**SOLICITATION AMENDMENT
MODIFICATION DE L'INVITATION**

Title - Sujet HVAC Upgrade Services	
Solicitation No. - N° de l'invitation EP922-210258/A	Amendment No. - N° modif. 003
Client Reference No. - N° de référence du client CFIA EP922-210258	Date 2020-08-30
GETS Reference No. - N° de référence de SEAG PW-SPWU-183-11872	
File No. - N° de dossier PWU-0-43037 (183)	CCC No./N° CCC - FMS No./N° VME
Solicitation Closes - L'invitation prend fin at - à 02:00 PM on - le 2020-09-08	Time Zone Fuseau horaire Mountain Daylight Saving Time MDT
F.O.B. - F.A.B. Plant-Usine: <input type="checkbox"/> Destination: <input type="checkbox"/> Other-Autre: <input type="checkbox"/>	
Address Enquiries to: - Adresser toutes questions à: Tikhonovitch (RPC), Alex	Buyer Id - Id de l'acheteur pwu183
Telephone No. - N° de téléphone (780) 901-7940 ()	FAX No. - N° de FAX (780) 497-3510
Destination - of Goods, Services, and Construction: Destination - des biens, services et construction:

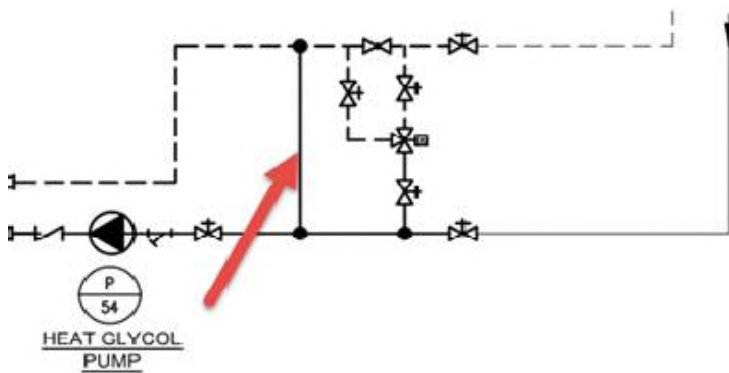
Question 2: 1. On Dwg M404 Detail 2, please provide pipe sizes for the Heating Glycol Schematic SF-15, 16 & 17.

Answer 2: The glycol supply and return branch sizing is as follows. Line sizing has been added to ADD-M02:

- SF-15/16 -> 100Ø GLYS and 100Ø GLYR
- SF-17 -> 50Ø GLYS and 50Ø GLYR
